**Hearings Examiner Meeting Agenda  
Wednesday, August 14, 2024, 4:00 PM  
Council Chambers, 616 NE 4th AVE**

Valley Street Duplex

*File Number: CUP23-04*

PROPOSAL: To request conditional use permit approval to construct a residential duplex on a property situated in the R-6 – Single-Family Residential Zone.

COMPOSITE UTILITY PLAN  
SCALE: 1" = 10'

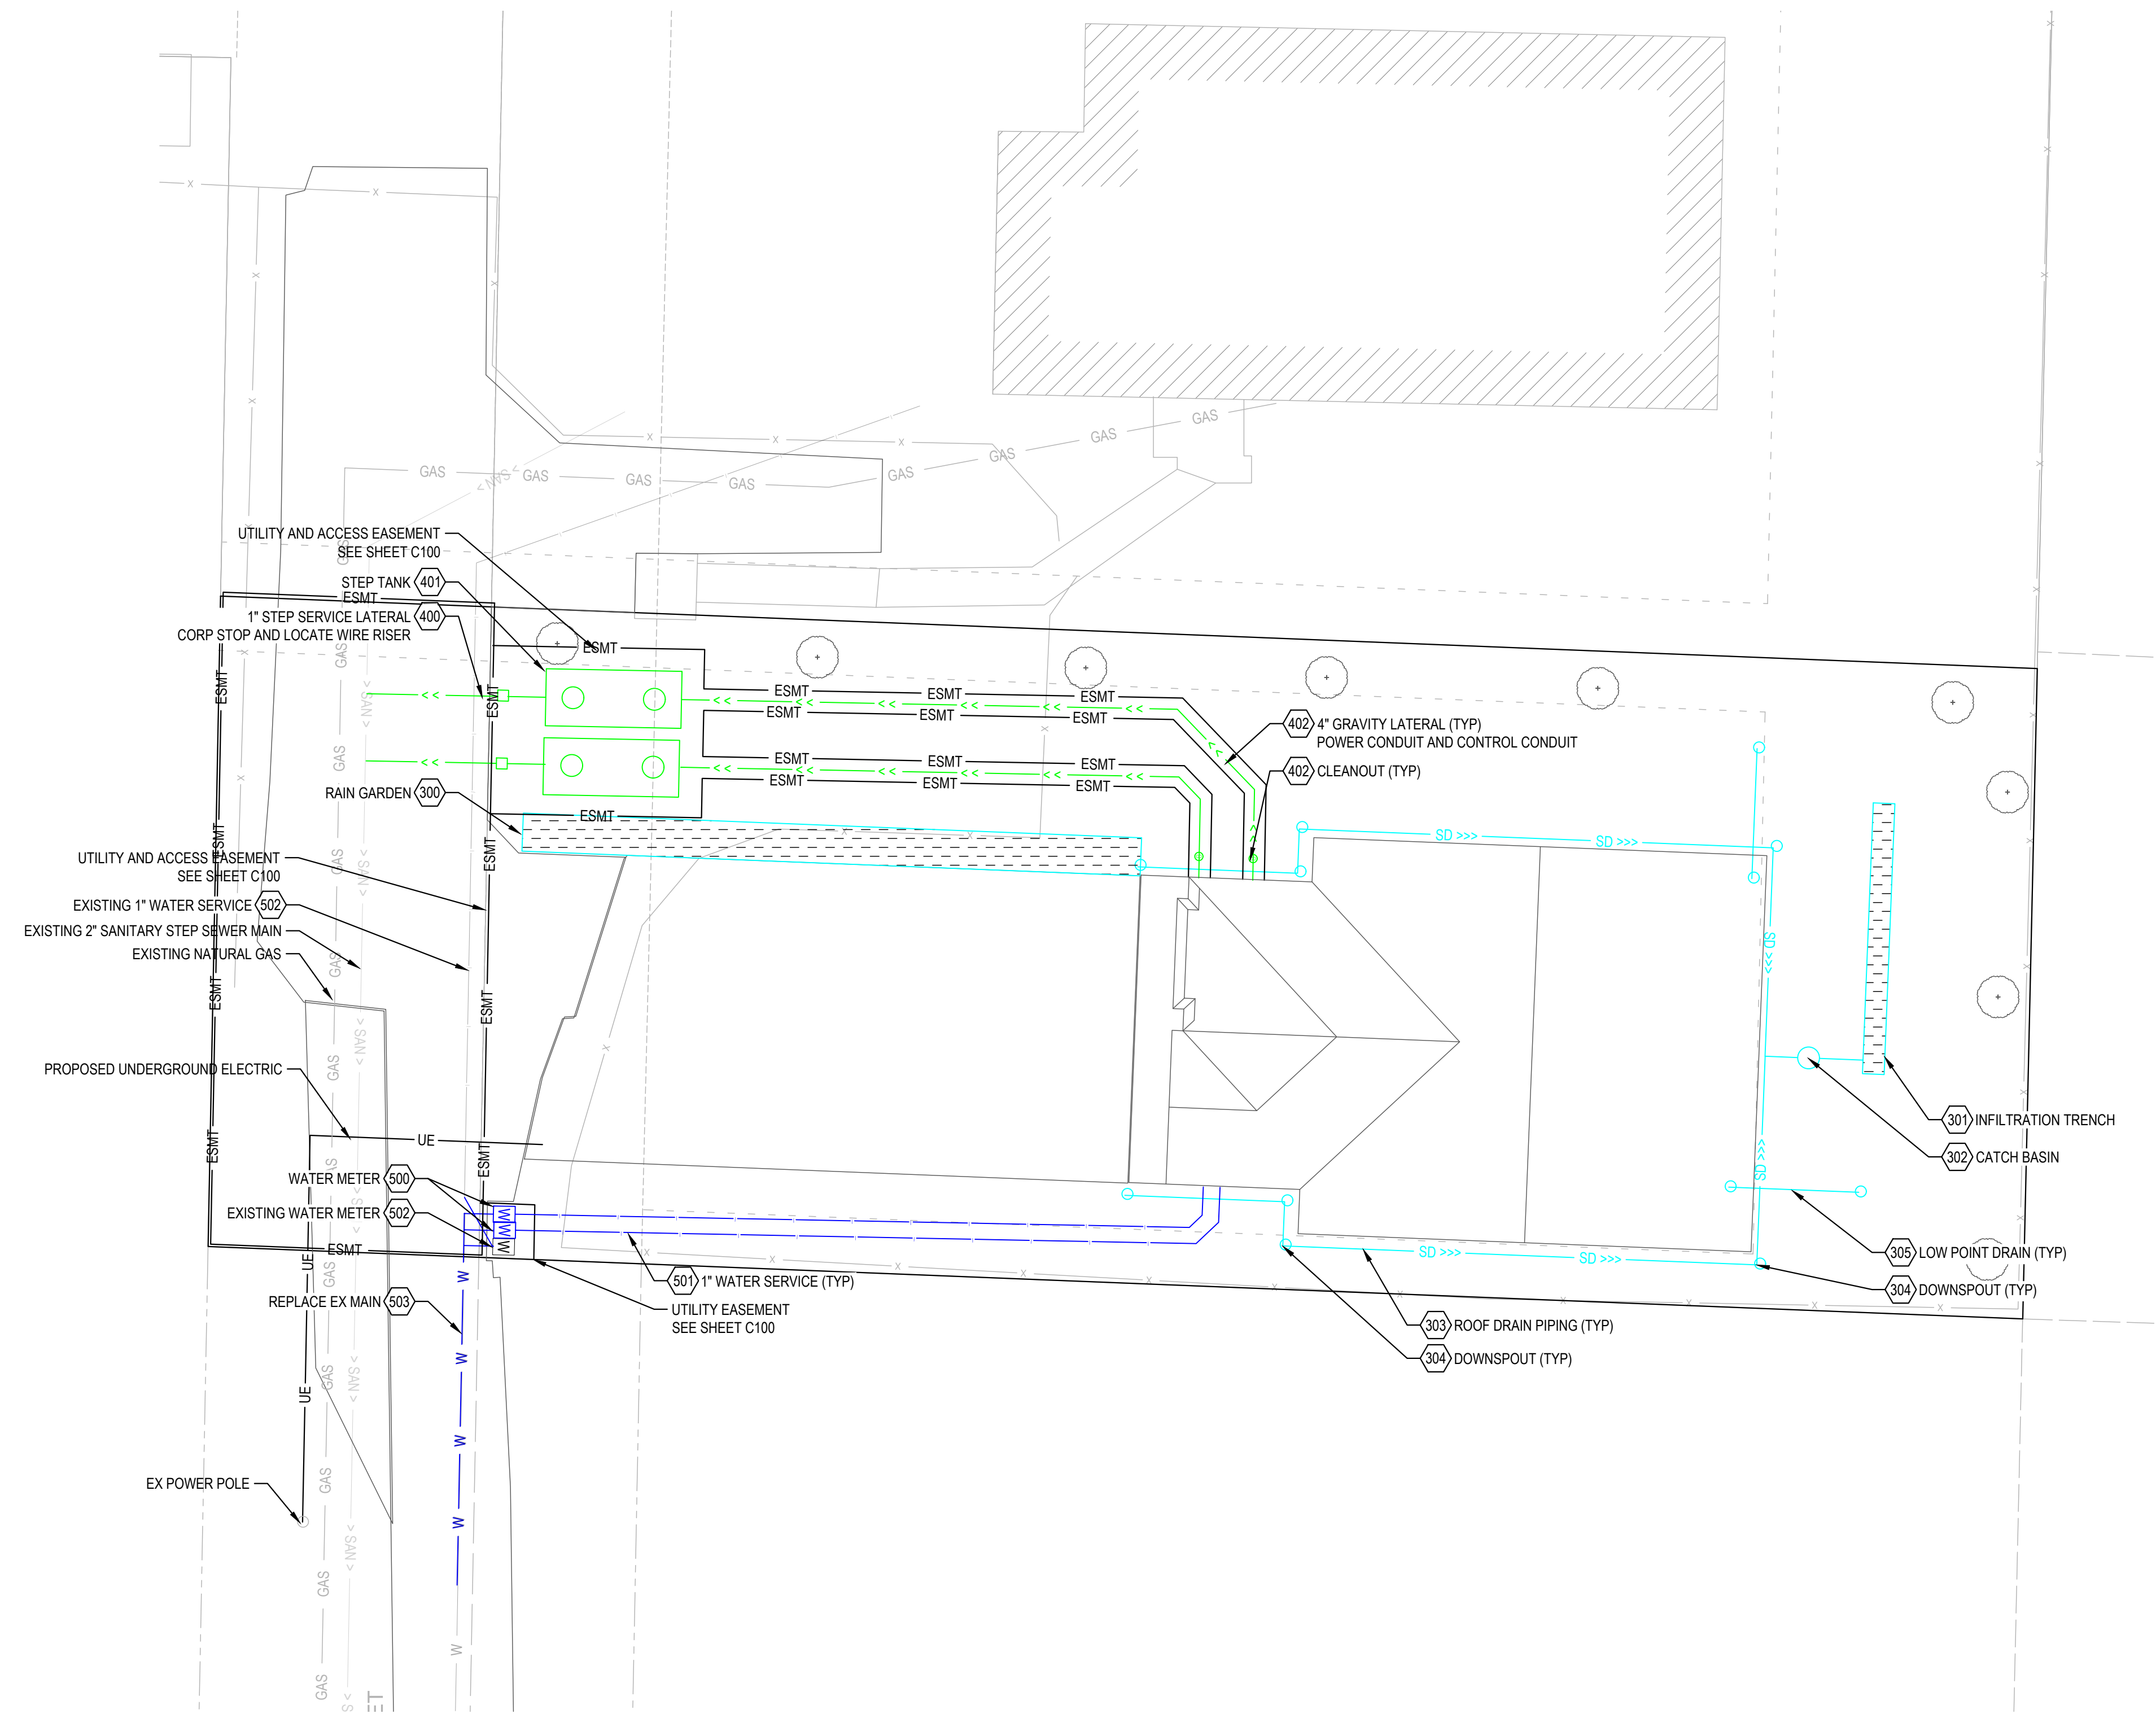
Staff recommends a condition of approval that prior to final engineering plan approval, the civil plans should be revised with the existing 2-inch pressure sewer main extended approximately 75-feet from the south property line of Parcel No. 83103000 to the north property line of Parcel No.

Staff recommends a condition of approval that prior to final engineering plan approval, the civil plans should be revised replacing approximately 70-feet of the existing section of 1-inch galvanized water main and extending approximately 70-feet of new 2-inch ductile iron water main from the south property line of Parcel No. 830103000 to the north property line of Parcel No. 830103000.

18. The civil plans should be revised with the existing 2-inch pressure sewer main extended approximately 75-feet from the south property line of Parcel No. 8310300 to the north property line of Parcel No. 8310300 and to relocate the AARV to the north end of the extended pressure sewer main. Two separate 1-inch pressure laterals are to be stubbed from the main to the future STEP tanks.

19. The civil plans should be revised replacing approximately 70-feet of the existing section of 1-inch galvanized water main and extending approximately 70-feet of new 2-inch ductile iron water main from the south property line of Parcel No. 830103000 to the north property line of Parcel No. 830103000.
  - a. Two separate 1-inch water services and water meter boxes are to be provided: one per dwelling unit.
  - b. The city will be responsible for tapping a new 1-inch water service on the extended 2-inch water main for the existing single-family residence on Parcel No. 83124000.
  - c. The applicant is to work with staff to determine the location for extending the 2-inch water main.

# LANDSCAPE PLAN

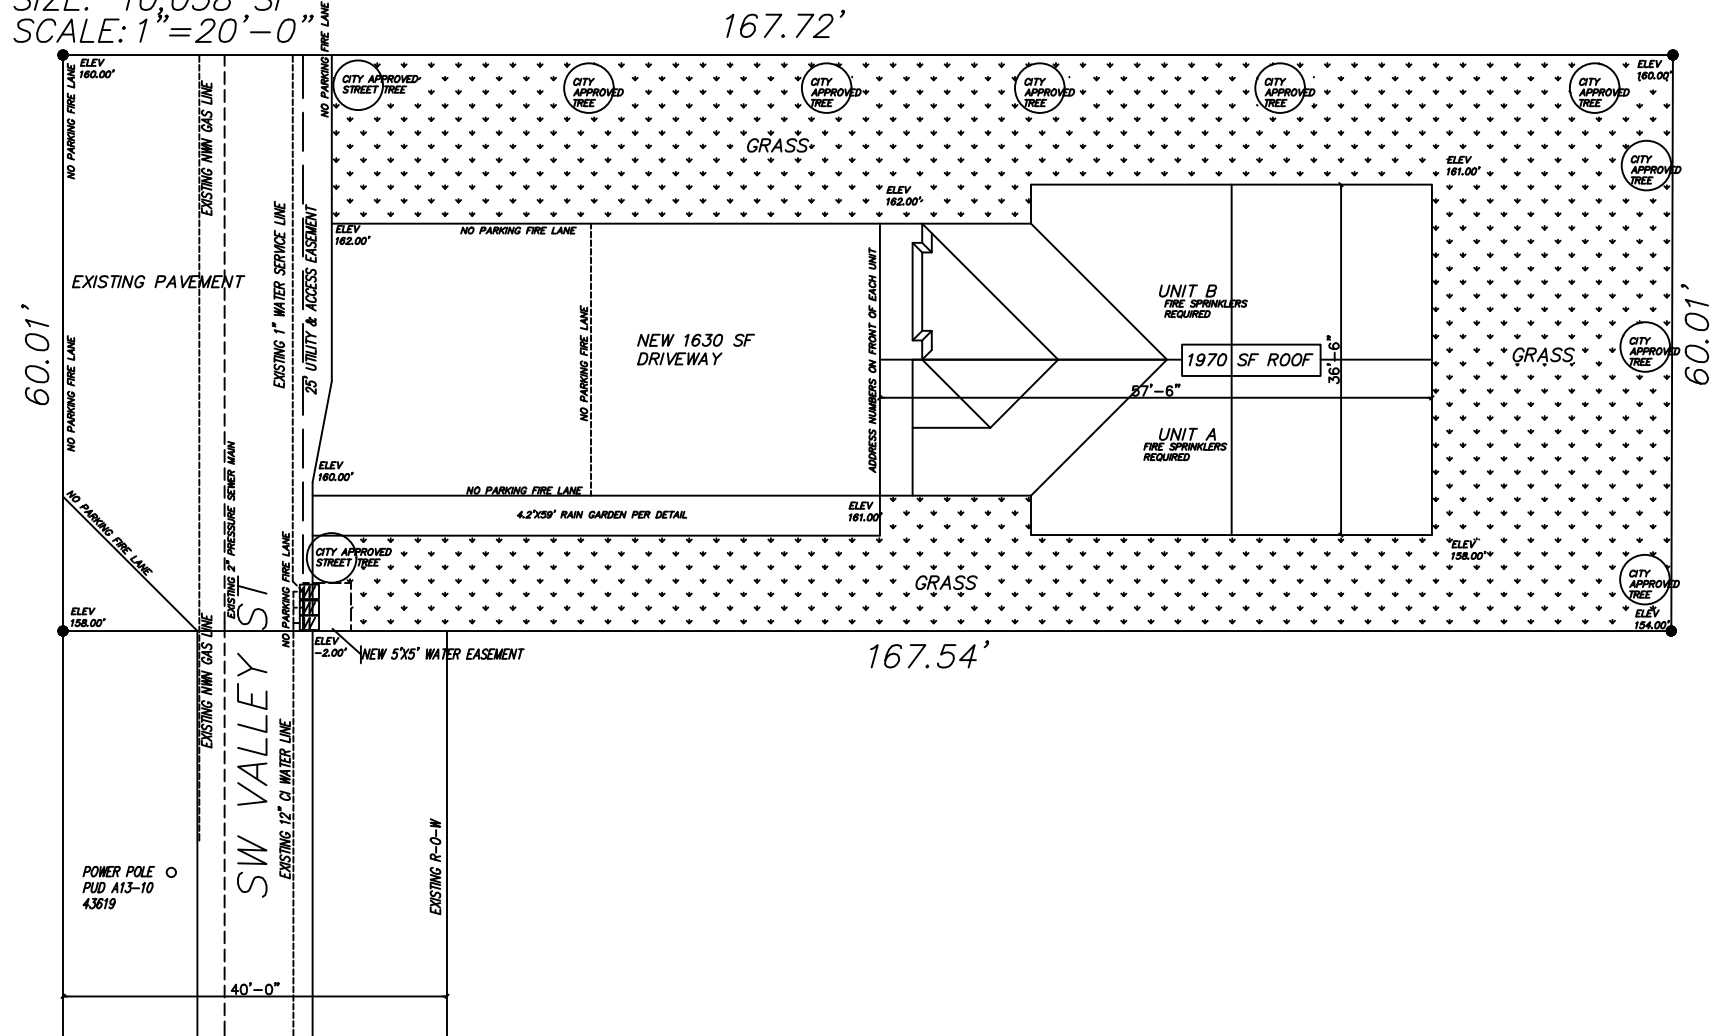
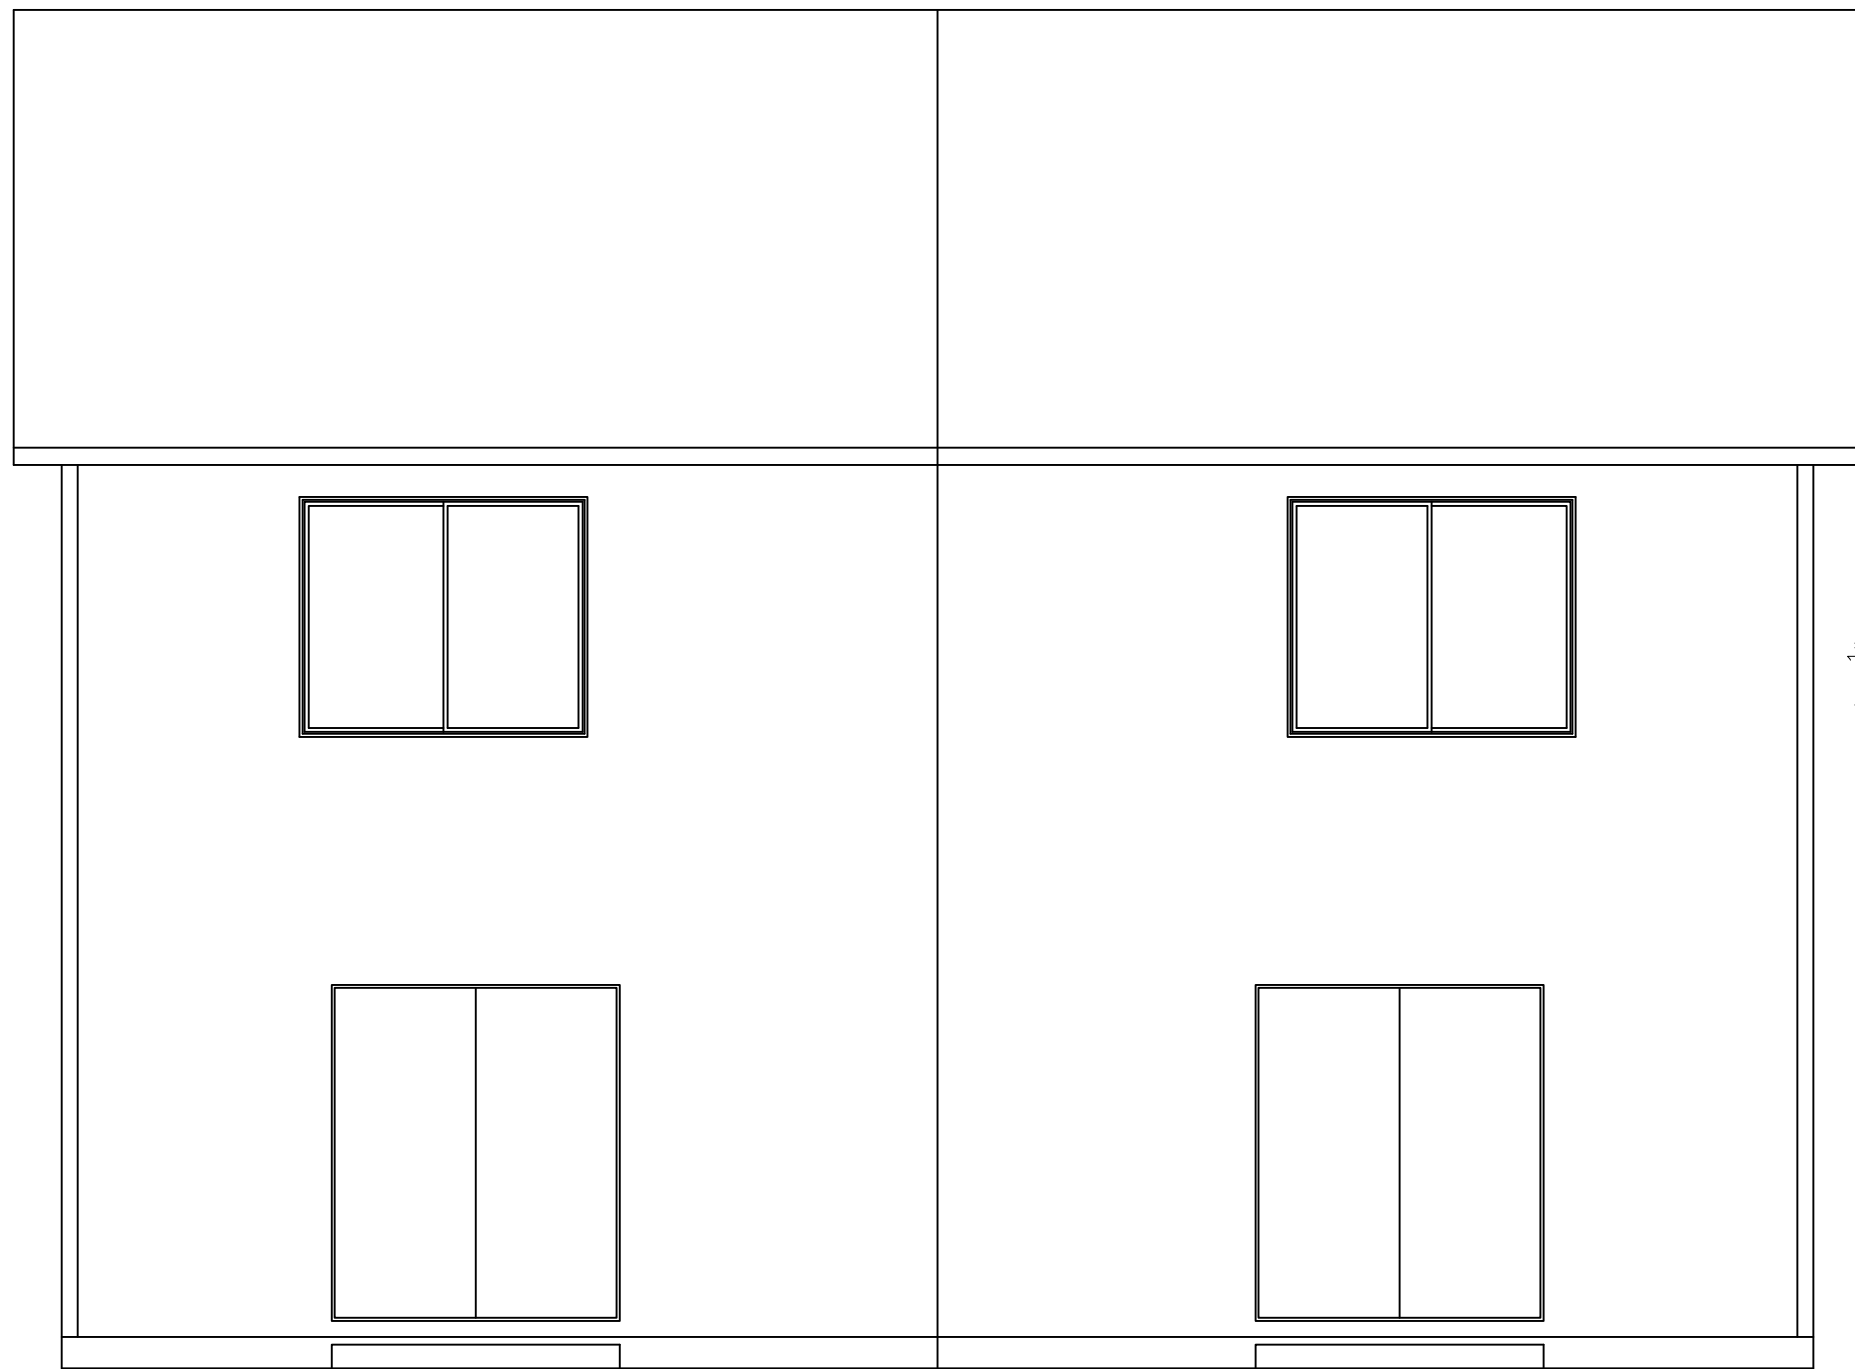
The preliminary landscape plan is showing 2 street trees along SW Valley Street, along with an additional 5 trees along the northerly side property line and 3 along the rear (easterly) property line. Grass is also proposed to be planted in front, sides, and rear yard areas. The proposal must also comply with the applicable landscaping standards in CMC Chapter 18.13. Per CMC 18.13.055(A) Table 1- Landscape Buffers, a 5-foot (L1) landscape buffer is required for multi-family uses (i.e. duplexes) abutting residentially zoned property. The project site is adjacent to residentially zoned properties on both sides. For compliance with this standard, the final landscape plan should be revised to reflect a 5-foot L1 landscape buffer per CMC 18.13.055.B.1 or a fully sight-obscuring fence be installed per CMC 18.13.055.B.4.b. Staff finds the landscape buffer criteria can be met, and a condition is warranted.

There are no significant trees on site. Per CMC significant trees include “*evergreen trees eight inches DBH, and deciduous trees twelve inches DBH*” and “*does not include hazard trees or invasive species*”. The applicant is required to provide 20 tree units per acre per CMC 18.13.051. The property is .23 acres and as such, 5 tree units are required. Although the preliminary landscape plan indicates a total of 10 new trees to be planted on site, the tree sizes are not specified on the preliminary landscape plan.

A final landscape plan consistent with the landscaping standards in CMC Chapter 18.13 and the Camas Design Manual planting specifications and landscape notes should be submitted to the City for review and approval prior to engineering plan approval. Trees should be installed prior to final occupancy and conditioned as such.

9. Prior to engineering plan approval, a final landscape plan consistent with the landscaping standards in CMC 18.13.050 and the Camas Design Manual planting specifications shall be submitted to the city for review and approval.

10. The final landscape plan shall reflect a 5-foot L1 landscape buffer or fencing around the sides and rear property line in accordance with CMC 18.13.055 – Table 1.

11. The final landscape plan shall note proposed tree sizes as to ensure the project will meet or exceed the 20-tree-unit per acre requirement for new development.
